**RE: EAST REGIONAL LANDFILL EXPANSION
APPLICATION SUBMITTAL-REVISION AUGUST 2026**

Case Name/ Number: East Regional Landfill / EXG2026-00002

Attachment 2: Written Explanation Of Purpose And Improvements

**Grade Survey Showing the Overfill Areas with Change To
Original Final Grades and Proposed Final Grades**

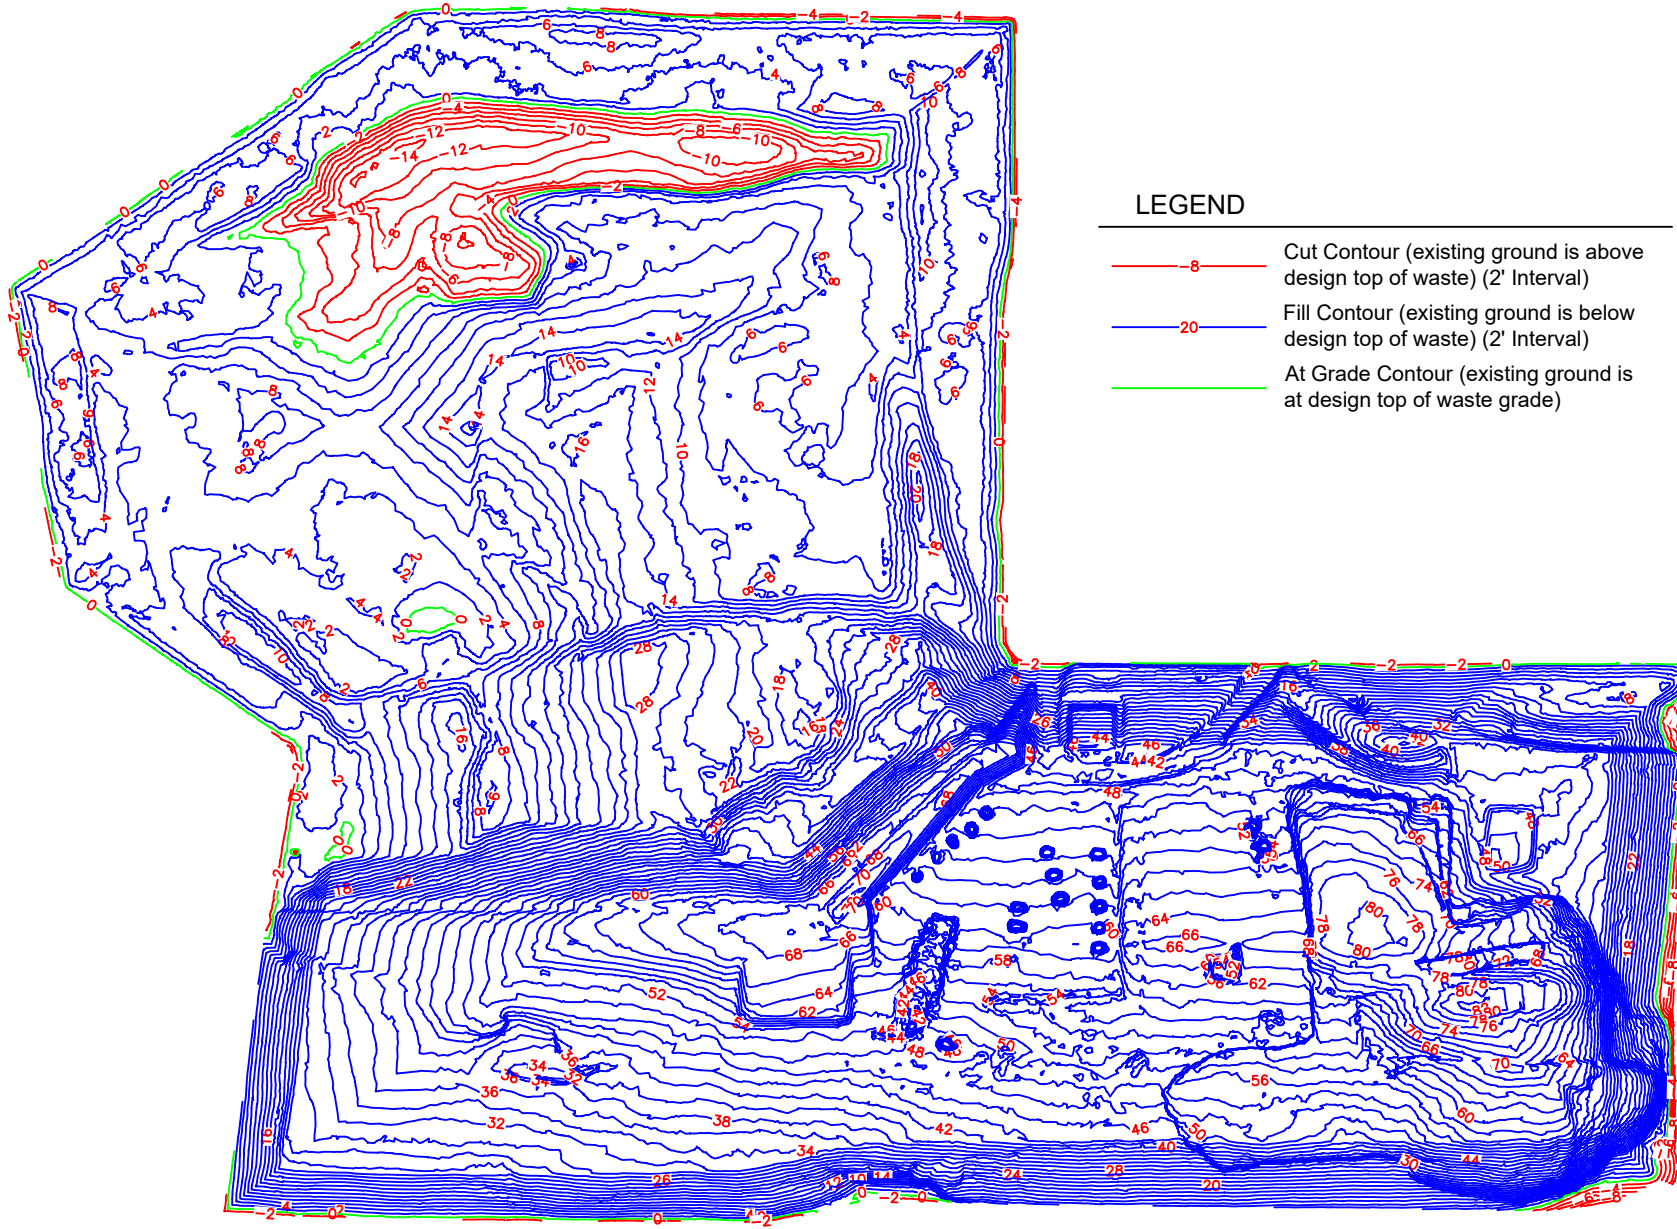
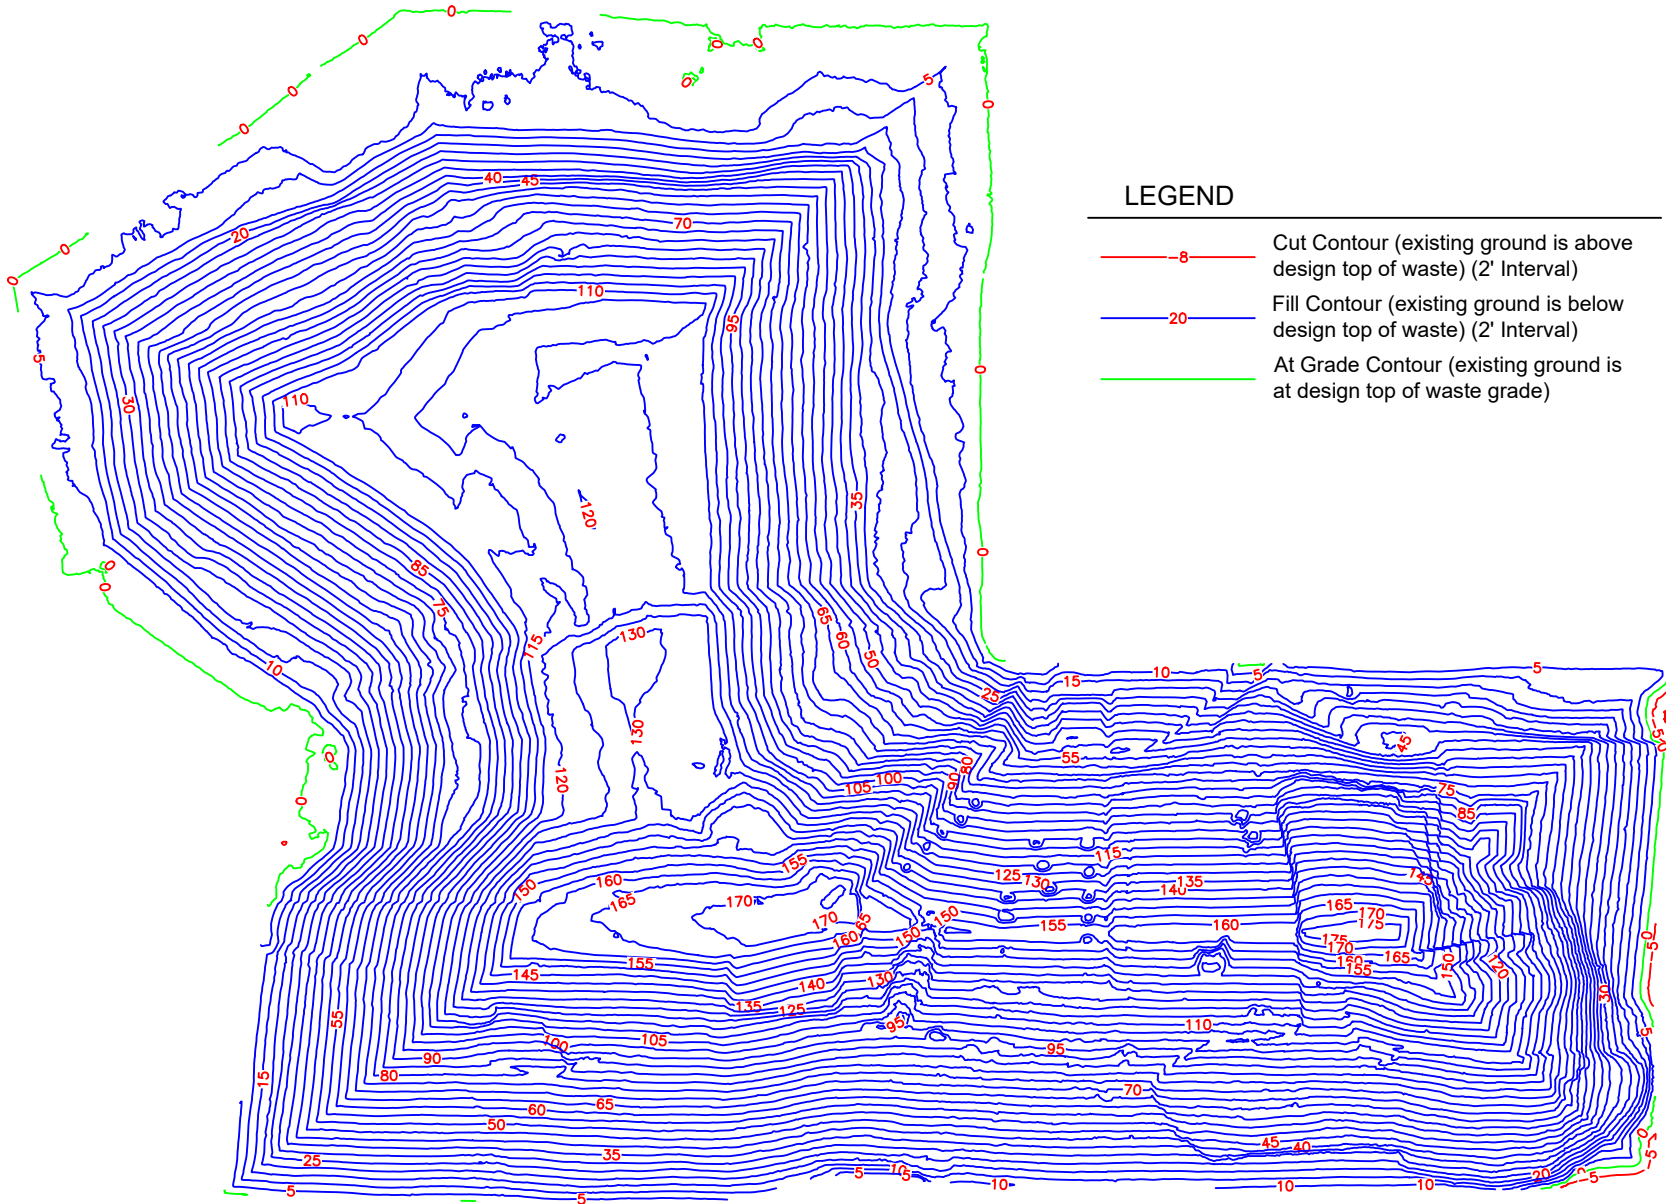
1. Grade survey showing the overfill areas with change to proposed final grades:

2. Justify change as for overfill remediation

Attachment 2-1 includes a drawing showing the overfill on a plan view. Additionally, two cross-section drawings are included showing the permitted final cover and the proposed final cover views.

The landfill was overfilled over an area of approximately 7.3 acres and up to 14 feet over the permitted top of waste. The vertical expansion of the landfill will remedy the overfill and add much needed capacity to this landfill. The additional capacity is a benefit to the community helping to keep disposal costs reasonable, offering capacity in the event other landfills close temporarily or permanently, and minimizing the need to permit new landfills that likely will be farther away and more expensive for disposal.
